**DEPARTMENT OF THE ARMY**  
PITTSBURGH DISTRICT, CORPS OF ENGINEERS  
WILLIAM S. MOORHEAD FEDERAL BUILDING  
1000 LIBERTY AVENUE  
PITTSBURGH, PA 15222-4186

05 JULY 2018

SUBJECT: Request for Deviation from the Approved Water Control Plan at Berlin Lake, OH

Figure 1. Berlin Lake Modified Water Control Plan

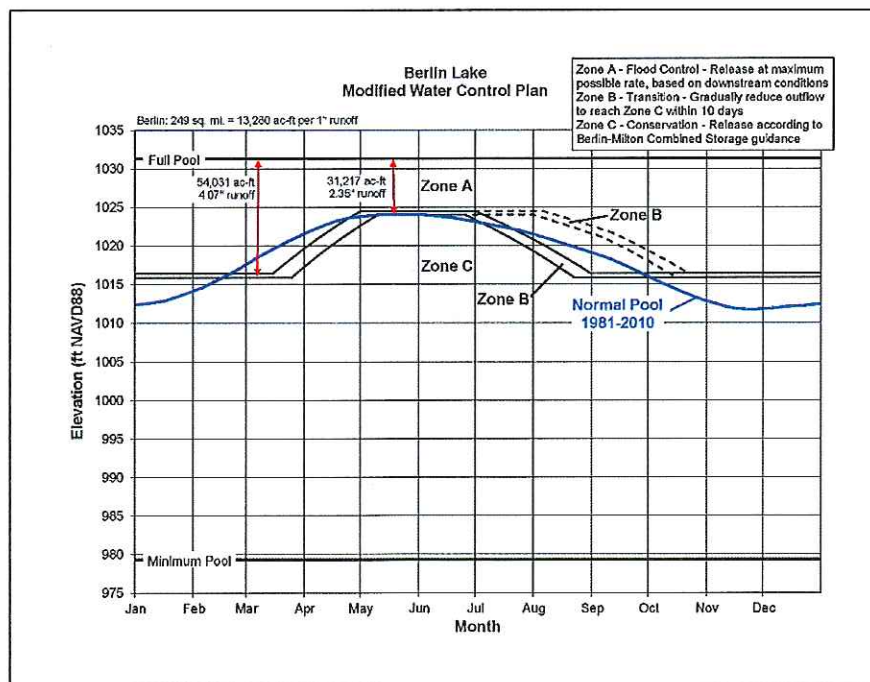
a. Deviation Description. To fulfil the request of the meeting participants, the District would have to deviate from the Berlin Lake Water Control Plan (WCP) from 25 June to 13 October, as shown in the Figure 1. The existing WCP is depicted by solid lines and it begins a drawdown at the end of June to reach winter pool by late August. The

visioning meeting participants have requested to hold the maximum summer conservation pool until the end of July, then gradually draw down to elevation 1021 ft (NAVD88) by Labor Day, and to the maximum winter conservation pool by the end of October. To achieve this result, the District would have to deviate from the WCP in a manner as depicted by the dashed lines in Figure 1. However, the District determined that such a deviation would not be feasible as it would violate two of the reservoir's authorized project purposes – downstream water quality and water supply schedule.

b. Therefore, the District is requesting from the Great Lakes and Ohio River Division (Division) a modification of the the visioning meeting members' request to temporarily deviate from the WCP and to hold the pool in the range of 1021-1024 ft (NAVD88) through Labor Day 2018, provided that the downstream minimum flow target is met at Leavittsburg, OH. This will allow the District to operate the reservoir per its authorized project purposes of flood control and downstream water quality and water supply. This deviation request will affect the water control plan from 25 June 2018 to 13 October 2018 only at Berlin Lake and will not affect the operations at Michael J. Kirwan Dam and Reservoir (MJ Kirwan) or Mosquito Creek Lake. A more comprehensive watershed assessment is required to properly study and model the Mahoning River watershed needs to then evaluate modifications to reservoir operations. The following information, analysis, and discussion pertains to the District's modification of the original pool adjustment request. Berlin Lake's WCP also includes Lake Milton's WCP in addition to the combined storage between them, as shown in Figures 2 and 3. Similar to Figure 1, the existing WCP is shown with a solid line and the proposed WCP is shown with a dashed line.

c. In summary, the District is requesting approval from Division to temporarily deviate from Berlin Lake's WCP from June 25, 2018 or thereafter to October 13, 2018 by holding the pool to the proposed WCP outlined in Figure 1, provided that the downstream minimum flow target is met at Leavittsburg, OH.

Figure 4. Berlin Lake Flood Seasonality Analysis

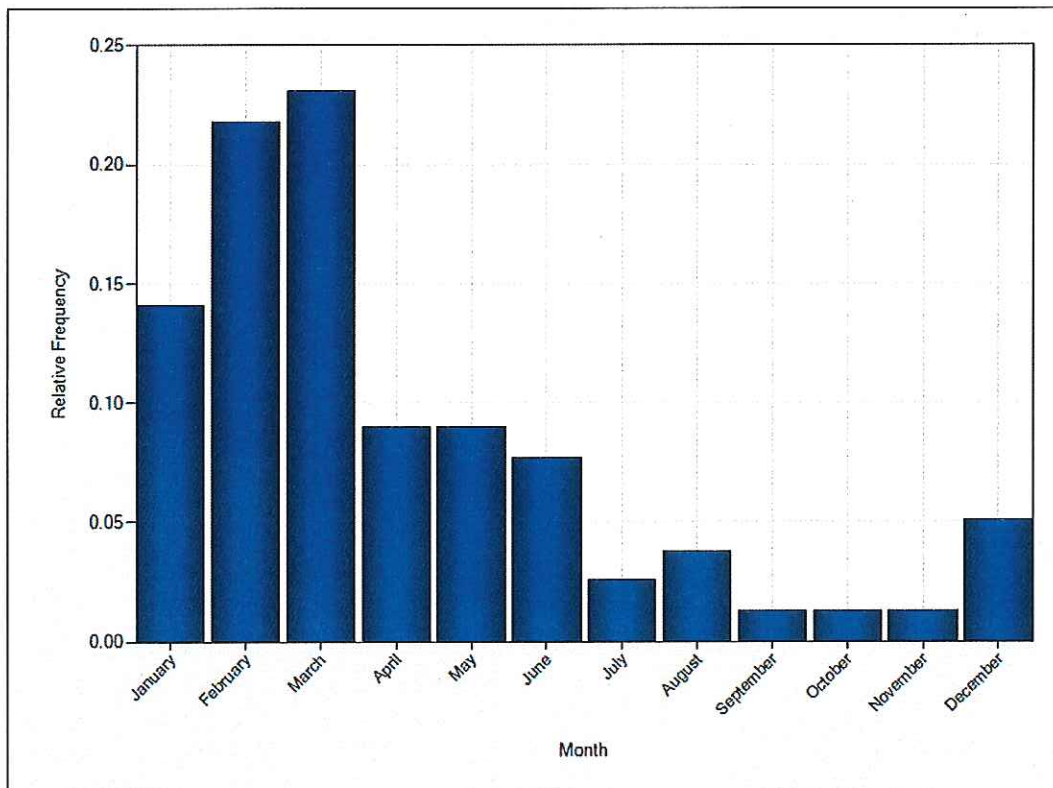
a. The Berlin Lake Flood Seasonality Analysis for the full period of record (1 March 1944 through 31 December 2017) is shown in Figure 4. Based on the full period of record, the relative frequency of a flood event occurring in July is 0.03 and the relative frequency of a flood event occurring in August is 0.04. This is compared with slightly higher relative frequencies in May and June of 0.09 and 0.08, respectively. The highest frequency of flooding occurs in February-March and the lowest frequency of flooding occurs in September-November. Based on these preliminary results, the risk of holding pool through July-August is not expected to be significantly higher than the risk that USACE currently assumes by holding summer pool in May-June. However, the cumulative relative frequency of flooding will increase from 0.17 (May-June) to 0.23 (May-August), which will increase the overall risk of higher pool elevations during the summer season.

Figure 5. Berlin Lake Stage (Elevation) Frequency Plot

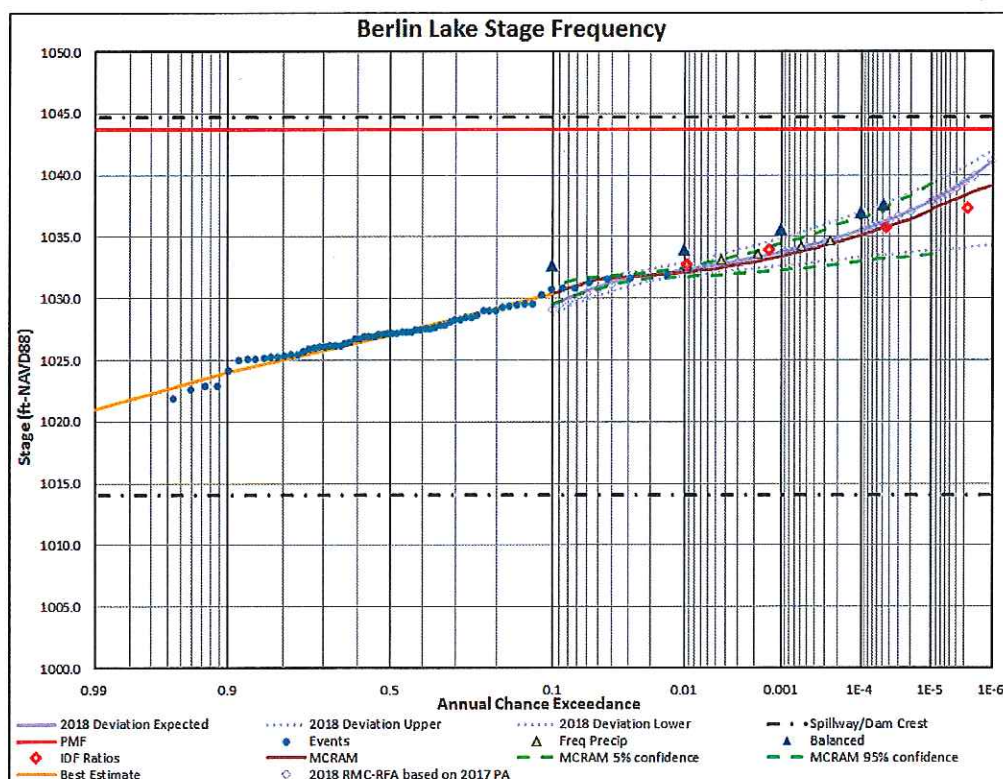
b. The stage (elevation) frequency plot shown in Figure 5 is based on the 2017 Berlin Periodic Assessment work. The 2017 PA Monte Carlo Reservoir Analysis Model (MCRAM) analysis was used as input to Risk Management Center – Reservoir

Frequency Analysis (RMC-RFA) program and the resulting stage frequency curve is labeled as the "2018 RMC-RFA based on 2017 PA". For the purposes of this deviation request, the RMC-RFA analysis was updated to include adjustments to the reservoir starting stage duration table. As a worst case assumption of starting pool under the 2018 Planned Deviation, the May starting stage duration data was copied to June and July and the original July starting stage duration data was copied to August-October. The resulting stage frequency curve is labeled as the "2018 Deviation Expected". Upper and lower uncertainty bounds representing the 90% confidence limits (5% and 95% exceedance curves) are also shown and closely agree with the 2017 PA MCRAM confidence limits.

c. The 2017 PA MCRAM analysis actually produces slightly more frequent pool loadings below an Annual Chance of Exceedance (ACE) of 0.02 compared to the RMC-RFA analysis using the same data, so any differences between the MCRAM and RMC-RFA analyses are probably within the margin of error associated with these tools, since the confidence limits are similar. There are no significant differences between the RMC-RFA analyses using the 2017 PA assumptions, versus the worst case (reservoir starting stage duration table) for the 2018 Planned Deviation. These minor differences illustrate from a flood control or hydrologic loading standpoint that the risks of holding pool higher in July-August, and even July-October are minimal.
